MODEL  
**LEGEND**  
 4-DOOR

BULLETIN NO.  
**92-010**

## Door Mirror Vibrates

(Supersedes 92-010, dated June 8, 1992)

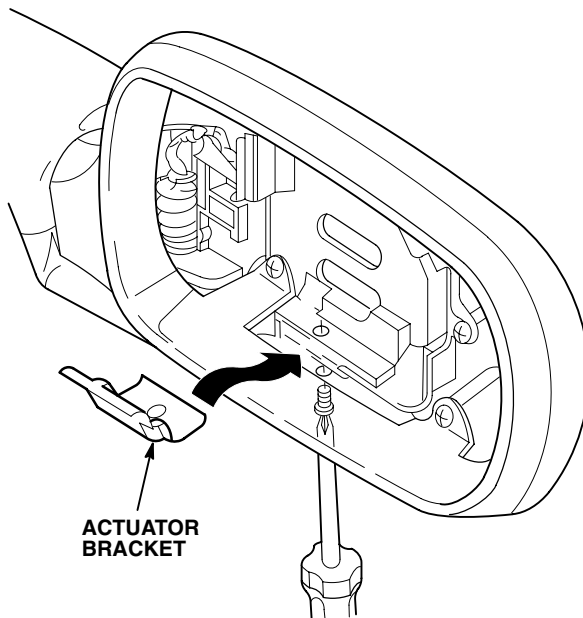
The door mirror glass vibrates due to insufficient tension of the door mirror actuator bracket.

Replace the actuator bracket and mounting screw (see PARTS INFORMATION).

1. Working through the service hole, use a #2 Phillips screwdriver to loosen the actuator retaining screw. (See mirror glass replacement in section 20 of the appropriate service manual.)
2. Remove the mirror and actuator assembly by lifting up, then pulling out the lower edge of the mirror.
3. Remove the 3 x 10 mm actuator retaining screw and the actuator bracket.

4. Position the new actuator bracket over the service hole.
5. Put the new screw on the screwdriver, and align the retaining bracket. Start the screw, but don't tighten it yet. Be careful to not cross-thread the screw.

6. Connect the two actuator connectors, and install the mirror assembly. Install the top edge first, then the bottom edge.
7. Tighten the retaining screw.
8. Turn the ignition switch ON, and check the mirror operation.

Actuator Bracket P/N 04769-SP0-J01  
 (Includes 4 x 8 mm screw)
